Groundwater Application Review Summary Form

Application # G- 19410

PUBLIC INTEREST REVIEW FOR GROUNDWATER APPLICATIONS

TO: Water Rights Section
FROM: Groundwater Section James Hootsmans/Travis Brown
SUBJECT: Application G- 19410 Supersedes review of _____
Date 10/31/2024
Reviewer's Name
Date of Review(s)

Water-Level Measurements in Nearby Wells

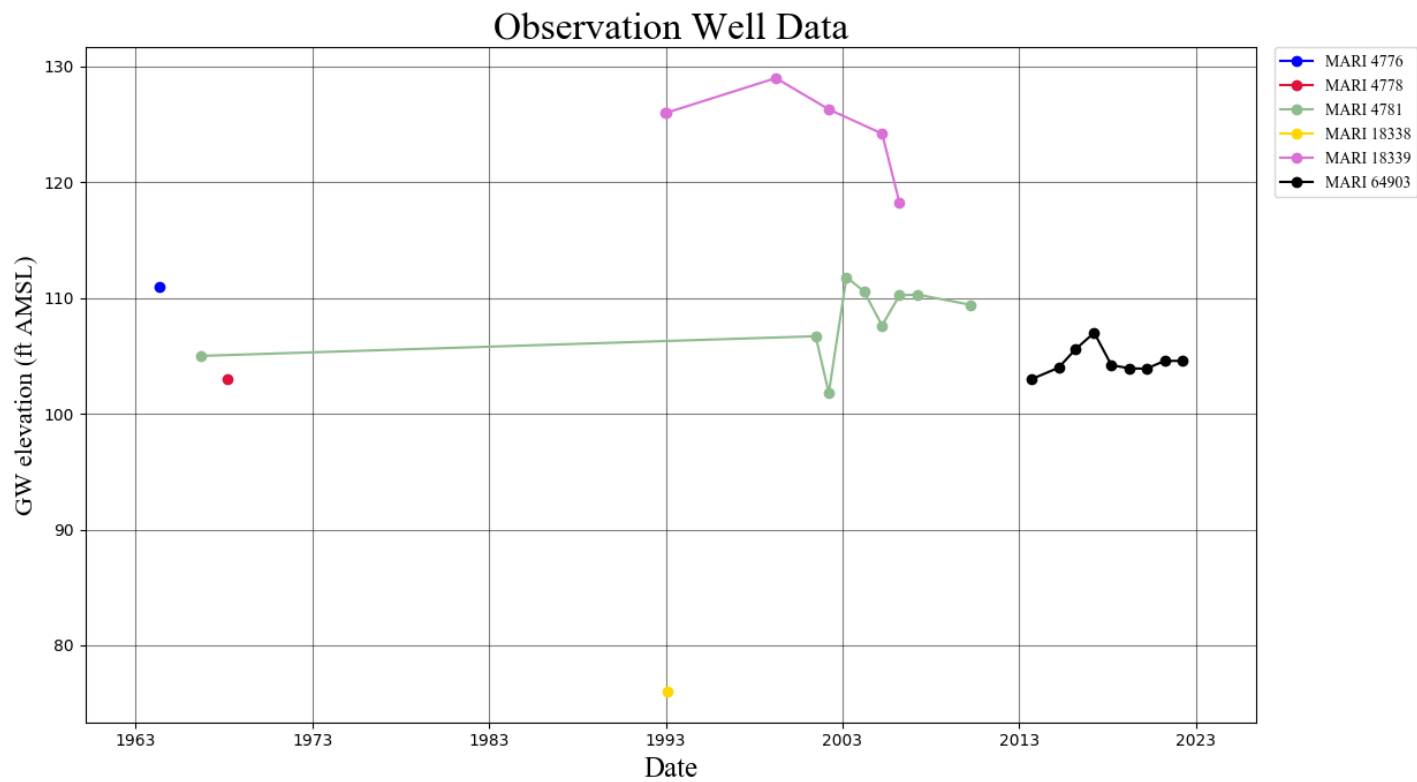
The water table is about 10-40 feet below land surface, so the POA will be saturated most of the total depth of the well. Water level data available from nearby wells in the sedimentary aquifer system show fairly stable trends over the past ~60 years (see attached hydrographs). However, water-level data from MARI 3803 indicate that seasonal fluctuations range from 20-35 feet and that water levels fall to within <20 feet of the top of the sand and gravel layers. These seasonal fluctuations are consistent with those found in much of the alluvial aquifer of the central Willamette Basin and likely reflect the combined interference from irrigation wells (Conlon and others, 2005).

Well Interference Analysis (Theis, 1935)Theis Drawdown and Recovery at $r = 400$ ft From Pumping Well

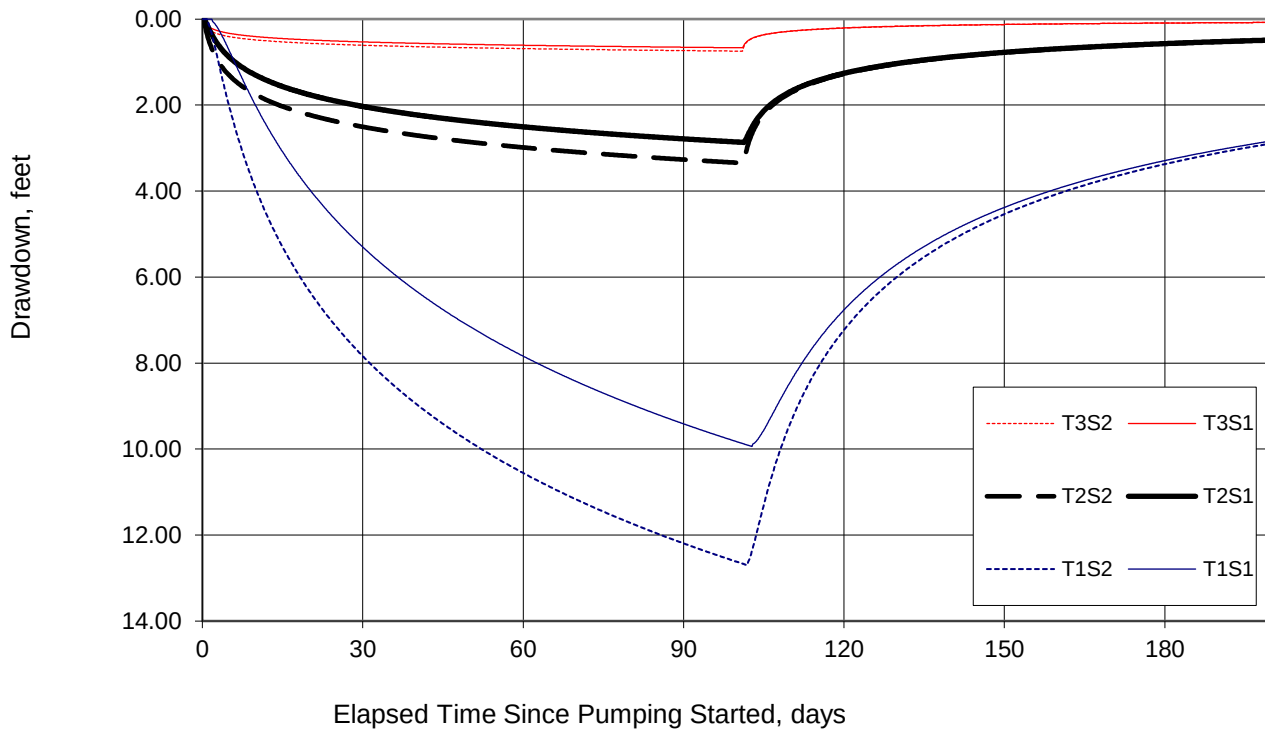
The nearest neighboring well to the proposed POA is MARI 4776, ~400 ft south of the proposed POA. Potential interference with MARI 4776 from the proposed use was assessed using the Theis (1935) solution (see attached Well Interference Analysis). Results of the analysis indicate the proposed use is unlikely to exceed the standard permit condition limit of 25 ft of interference with a neighboring senior water right or cause injury to MARI 4776.
